**CHANGE ORDER**

Construction of Barbara Jordan Park Community Center, 8705 Park Street, Needville, Texas 77461  
Bid No. 25-025

CHANGE ORDER NUMBER:..... 1  
DATE:..... 12/05/2025  
BID NUMBER:..... 25-025  
CONTRACT FOR:..... Construction of Barbara Jordan Community Center  
CONTRACT DATE:..... 1/28/2025  
FBC PURCHASE ORDER NO..... 253107

Description: Construction Changes & Additional Restroom

Drawing Name  
**ARCHITECTURAL OVERALL SITE PLAN**  
**AS-100**

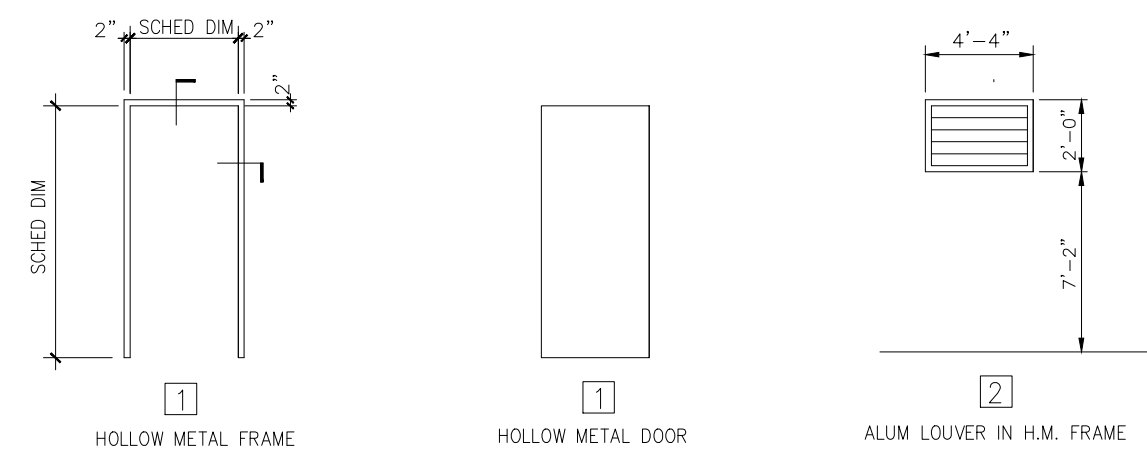
- 2 4" Telecommunication Conduit as requested
- Cost to Add New Restroom Per Attached Drawings
- General Conditions to Complete the New Restroom
- Project Duration Extension = Original Substantial Completion Date + X Days + 90 Days

SYMBOL	DESCRIPTION
①	8" DIA. PAINTED STEEL BOLLARD
②	5'-0" WIDE CONC. SIDEWALK
③	EXTERIOR TRAFFIC PAINT STRIPING
④	6" CONC. CURB
⑤	MECHANICAL CONDENSING UNITS, RE: MECHANICAL FOR ADDITIONAL INFORMATION
⑥	ADD (2) 4" PVC CONDUIT FOR FUTURE LOW VOLTAGE WIRES
⑦	
⑧	
⑨
